COMMENTS FOR VALLCO SHOPPING DISTRICT SPECIFIC PLAN DEIR

Draft Environmental Impact Report SCH# 2018022021

JUNE 6, 2018

Kitty Moore

Figure 42: Opticos Charrette #2

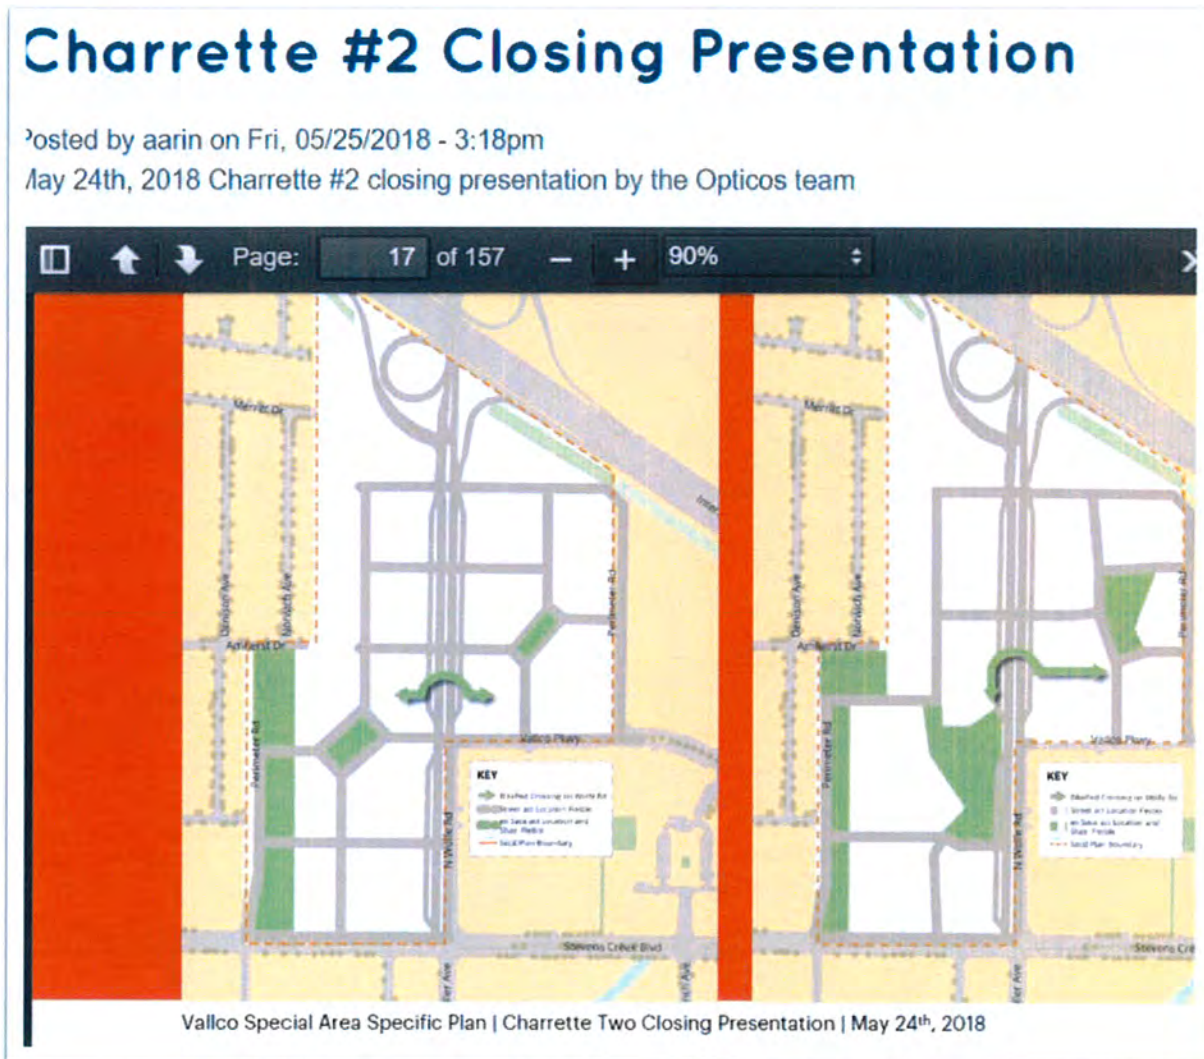
Charrette #2 Closing Presentation shows parks adjacent to back yards of single family residences. This may, combined with Perimeter Rd. noise exceed Municipal Code permissible sound levels. The DEIR does not adequately address this.

FIGURE 3.13-2

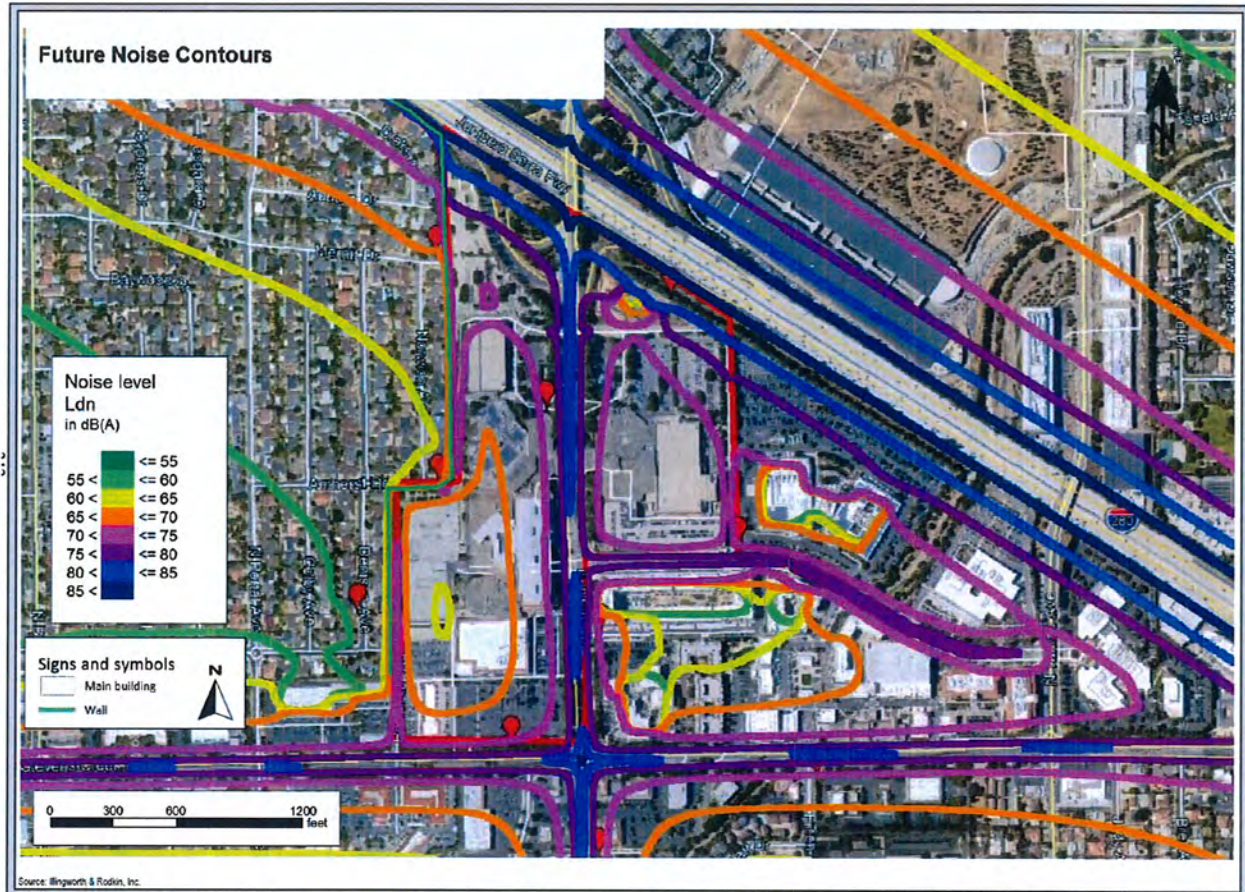
The Future Noise Contours map has some omissions regarding noise from the Perimeter Road, western edge park, and proposed amphitheater. The map has gross assumptions regarding what the plan would look like and ignores conditions on the roof which would result in a separate layer of mapping: One layer for ground level (ear level) and one level for the roof park to see if it meets park noise requirements.

The future noise contours for the project site exceed residential maximum levels according to the Cupertino Municipal Code 10.48.040.

Figure 52: Sample of local advertising showing higher employees per 1000 SF than studied

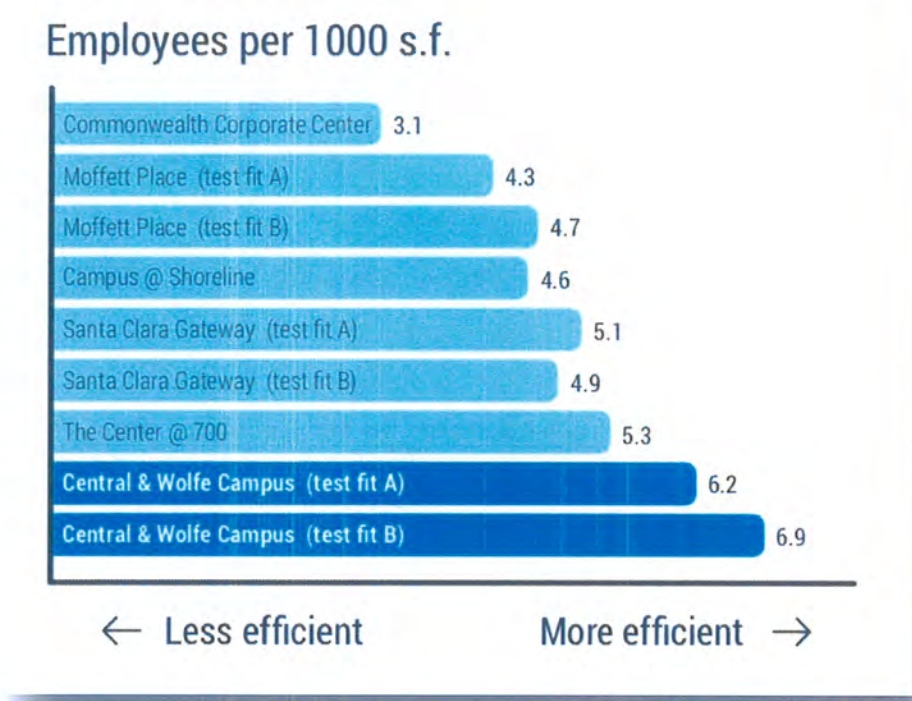
It is unclear, given that Apple Park has been occupying, how their (Apple Park) traffic has been assigned. For instance, there were traffic counts in May, 2017 which would reflect thousands of trips by construction workers to the site which would likely have been coming from the I-280 and east bound AM and westbound PM. There were also traffic counts in January, 2018, which would perhaps now show a few hundred Apple tech workers who would presumably be coming from other areas along with continued construction workers. As of March, 2018 approximately 6,000 employees were at Apple Park out of the expected 14,200. There have been many requests of the city to wait until Apple Park fully occupies to perform traffic counts. Main Street Cupertino was also under construction during May, 2017 and those construction workers would also be impacting the counts. There have been several intersections under construction, including the Calvert/I-280 project and Lawrence Expressway/I-280 exit project. These multiple projects have rerouted traffic and altered the makeup of drivers into artificial patterns not reflected in the study. What the traffic counts show, is what the area traffic is like with major construction underway.

Traffic impacts, while significant and unavoidable with mitigation is underestimated.
